RECONVENED MEETING OF ARGYLL AND BUTE LOCAL REVIEW BODY

- 1. APOLOGIES FOR ABSENCE**
- 2. DECLARATIONS OF INTEREST (IF ANY)**
- 3. CONSIDER NOTICE OF REVIEW REQUEST: 17/0008/LRB: 32 MACLEOD DRIVE, HELENSBURGH**
 - (a) Further Written Submissions from Planning Authority (Pages 3 - 8)
 - (b) Comments from Applicant on Further Information (Pages 9 - 14)
 - (c) Comments from Interested Parties (Pages 15 - 18)
 - (d) Comments from Applicant (Pages 19 - 22)
 - (e) Comments from Planning (Pages 23 - 24)
 - (f) Comments from Interested Parties (Pages 25 - 26)

**Proposed Additional Dwelling House at 32 Macleod Drive, Helensburgh, G84 9QU
Planning Application 16/01835/PP (Amended Plans)
Review Reference No 17/0008/LRB**

32 Macleod Drive Helensburgh G84 9QU

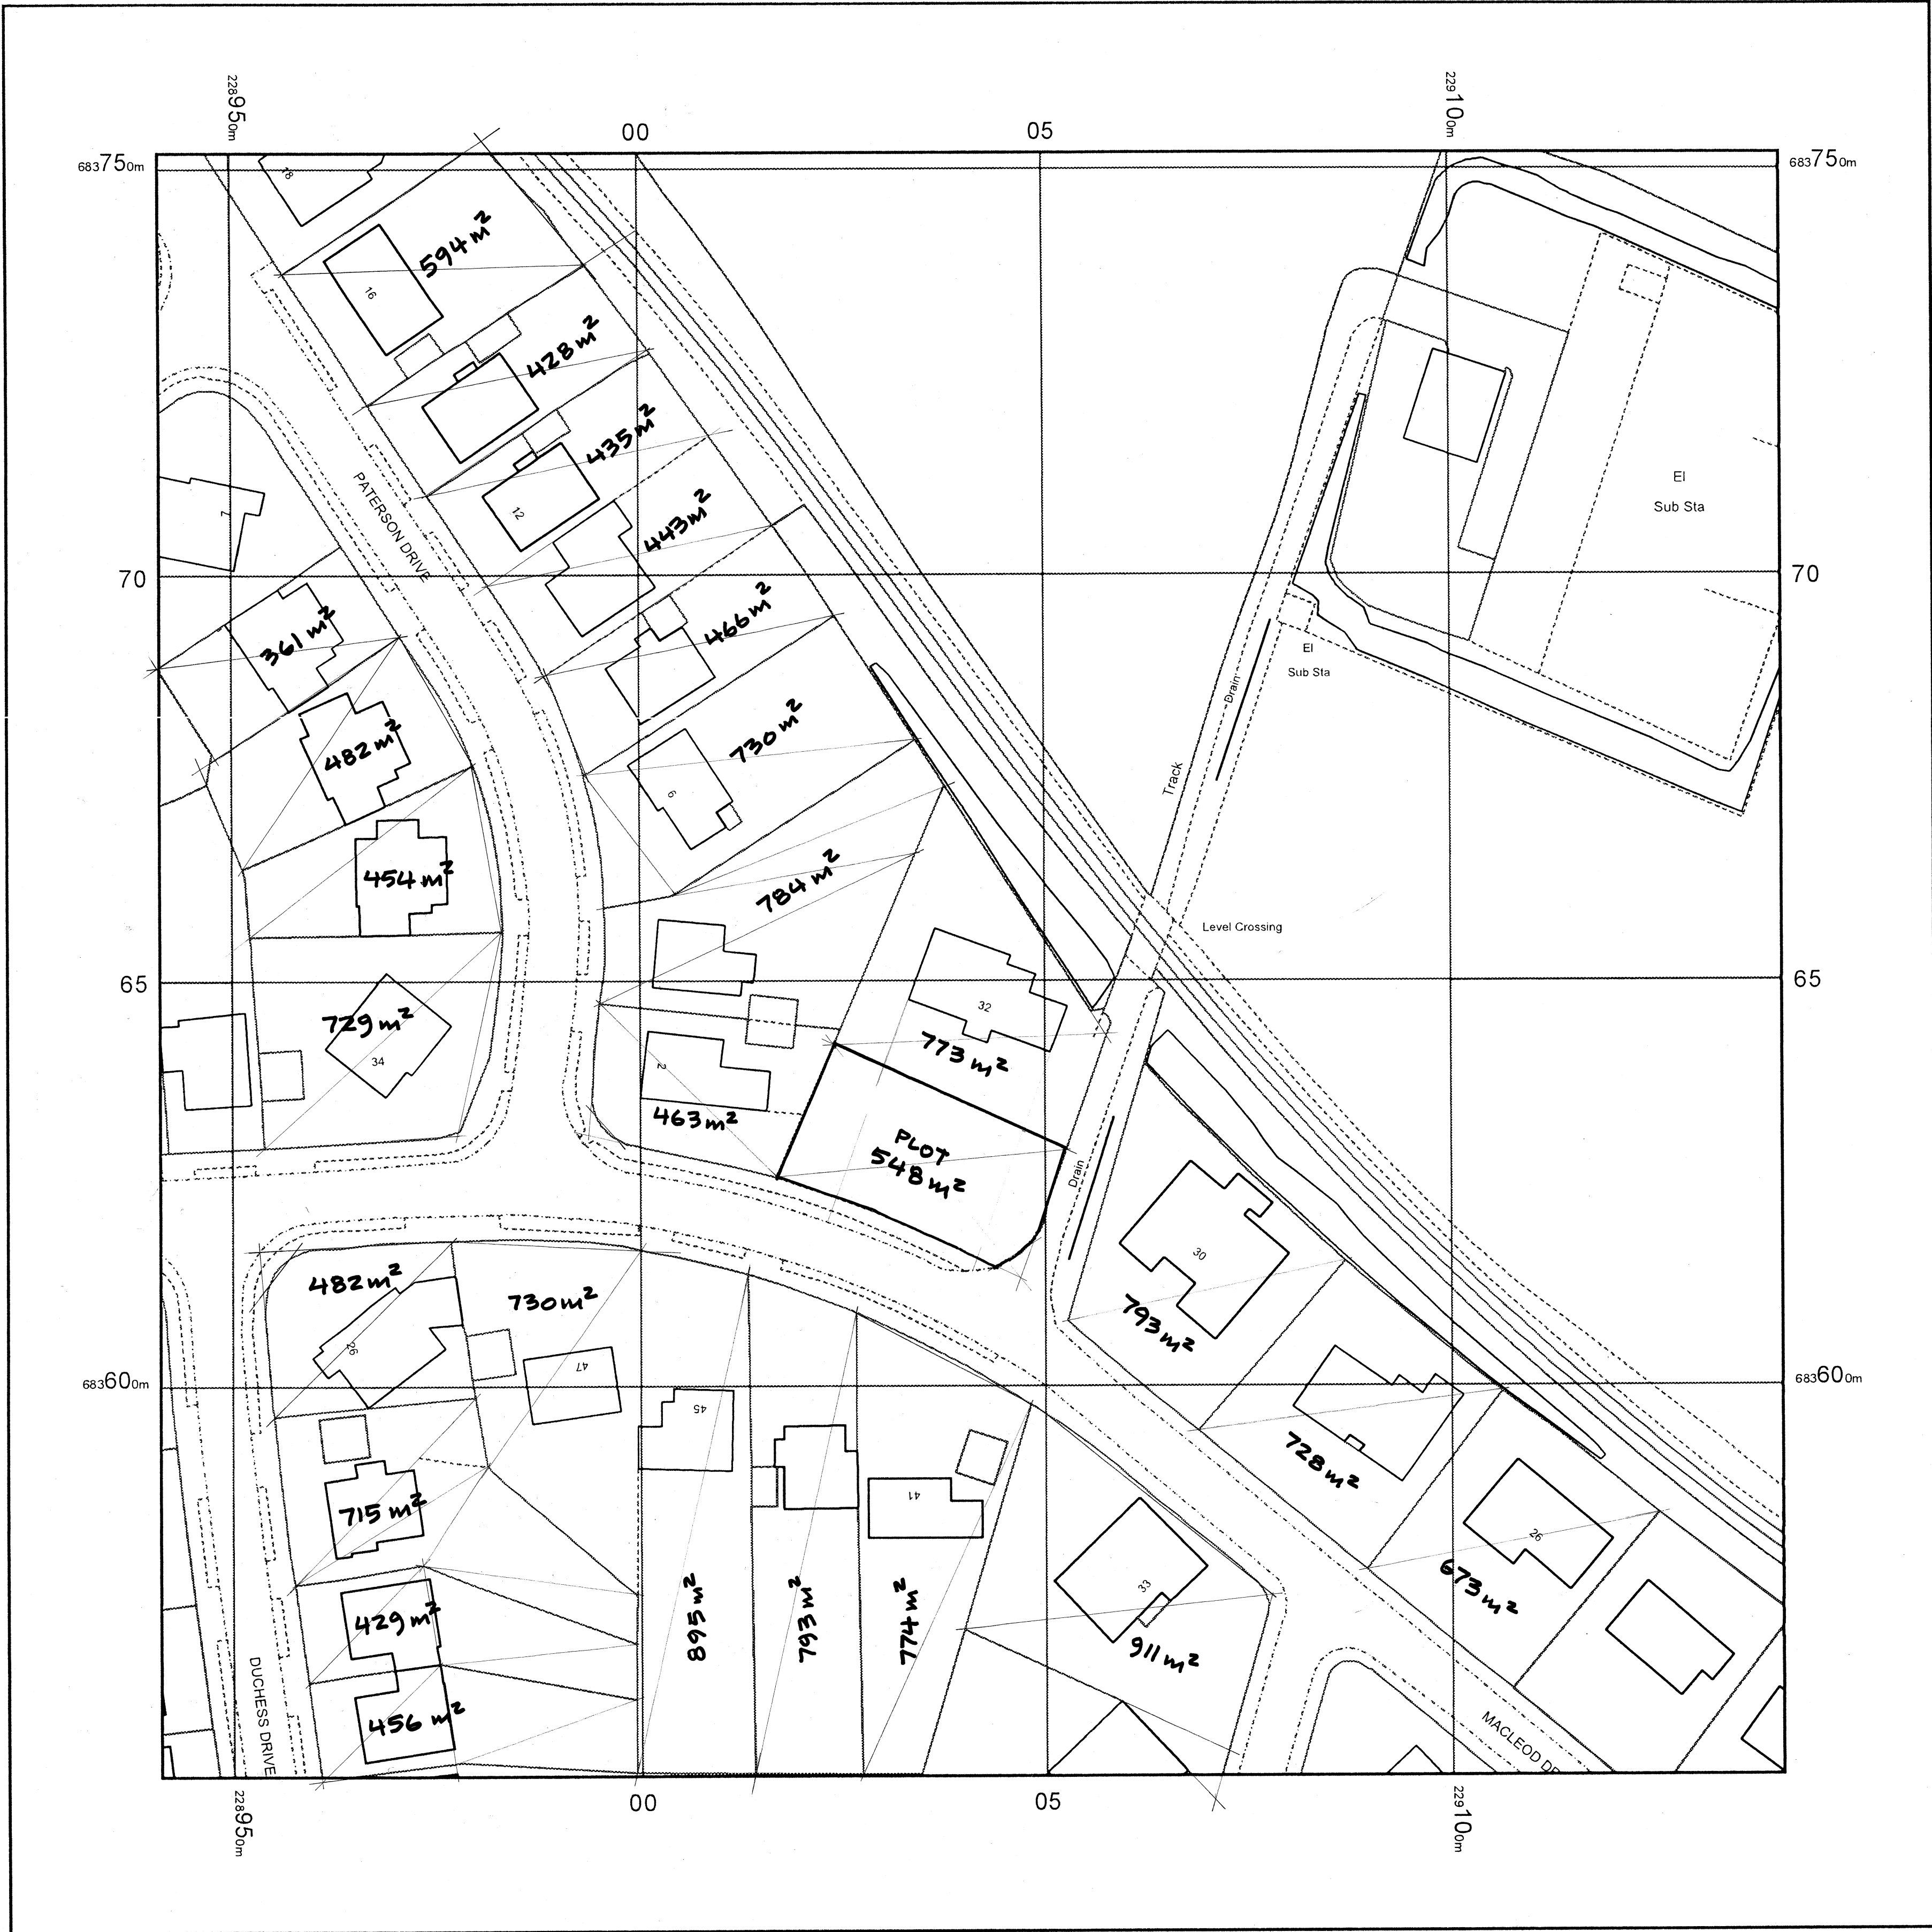
Hazel, we have now received the planning authority's plan showing the measured comparison plot sizes. By way of response we submit the attached plan which shows a greater range of surrounding plots compared to the Planning document and ask that this is taken into consideration. The plot sizes are similar in both documents but not exact, ours excludes pavements. The more extensive coverage we believe provides a better comparison.

Hazel, I appreciate you have asked A&BC Planning to produce a review of plot sizes however, in order to speed the process up, we have undertaken our own review of the relative plot sizes of properties in the vicinity of the application site; the results are shown on the attached plan. I trust this is useful.

PLAN 'A'

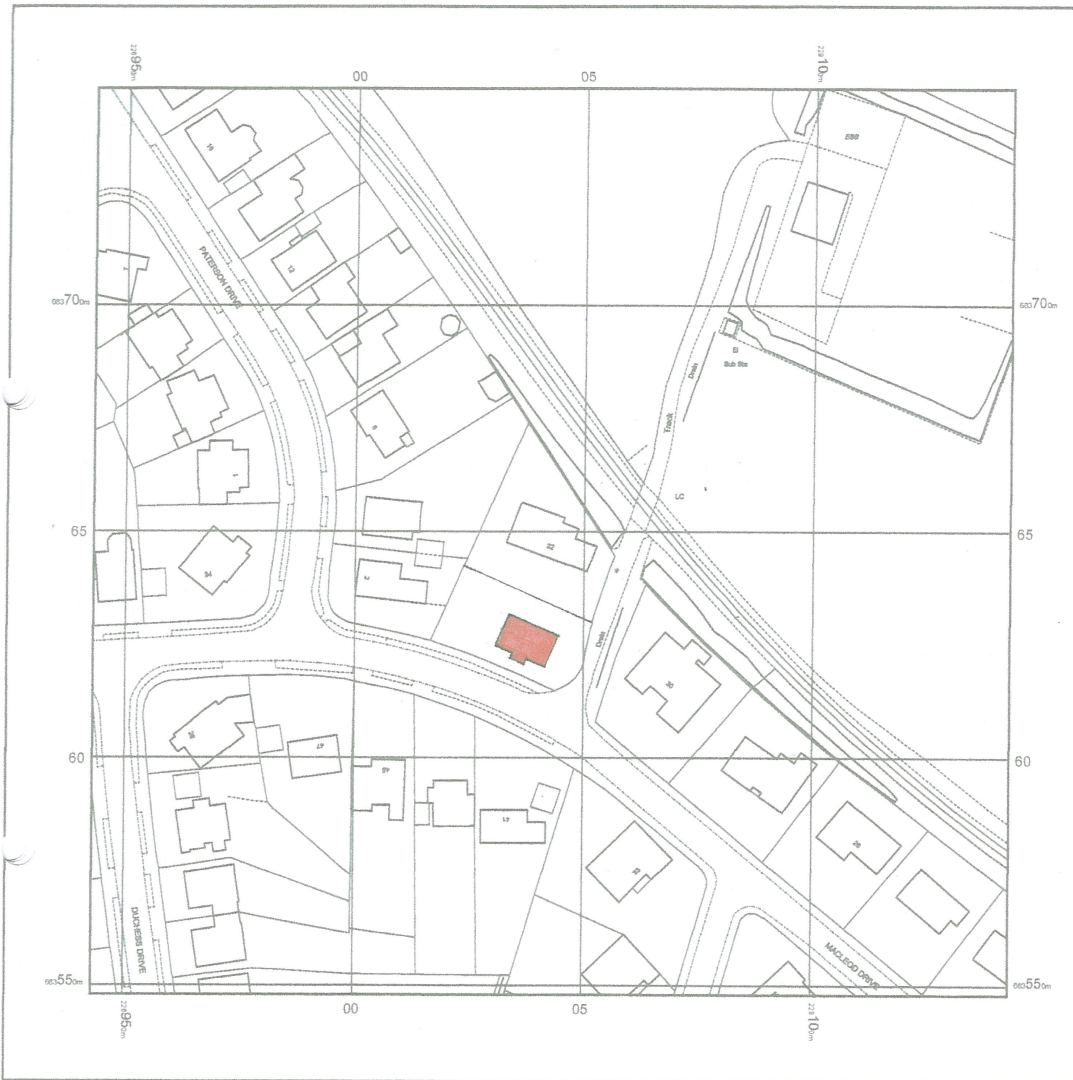
1. As stated in previous correspondence, my objections over the entire period of this application have been in relation to the siting of the proposed dwelling in such close proximity to the heel of the existing footpath. This location would set the proposed dwelling house well beyond a clearly established street building line. Please refer to attached Plan A.

2. I note that Cameron Consultants presents an ordnance survey map with the areas of all adjoining plots noted and the area of the proposed site. However, in my opinion, the area of the site in this instance is of no relevance. **I would draw the attention of the Local Review Body to the fact that it is the depth of the plot from the existing footpath on Macleod Drive which creates the problem for the applicant.** There is the requirement, recognised by both the planning officials and the applicant, that the distance between the existing and proposed buildings must be a minimum of 18 metres. **The result of this requirement is that (exclusive of the necessary access steps) the new dwelling would be a mere 2.1 metres from the heel of the public footpath, making it totally out of character within the location.**

5. **In summary, there is insufficient depth to the plot to accommodate the proposal.**

1. Building line and proximity to footpath – there is no specific Local Development Plan policy that establishes principles of building lines and whilst the proposed development does sit closer to the road than the objector's property there are numerous examples of other properties on McLeod Drive, Barclay Drive, Paterson Drive et., and throughout the estate, where dwellings are at a similar distance to the road as the proposed dwelling;

2. Mrs Jamieson states incorrectly that the Planners and the applicants recognise that there is an 18m minimum distance between properties 'rule' that the development doesn't comply with. This is incorrect. First of all there is no Local Development Plan policy that requires a minimum 18m distance between dwellings. There was historically a former Building Regulation (L10) which is no longer applicable under current Building Standards, which required that habitable rooms in different properties should be at a minimum 18m distance. The rule was in relation to habitable rooms only and the distance was calculated as a direct, square-on, level, window to window distance; the distance reduced depending level differences and off-set angles. The requirement was also waived where screening and the use of obscure glazing were employed. As regards the current application, there is no issue whatsoever as the only upper level window on the proposed dwelling is a bathroom window which will have obscure glazing; the proposed dwelling also sits lower than the existing dwelling and is off-set by a slight angle. **The key point here however is that there is no 18m distance rule and even if there was it applied to habitable rooms only, which in the case of the application is not relevant.**
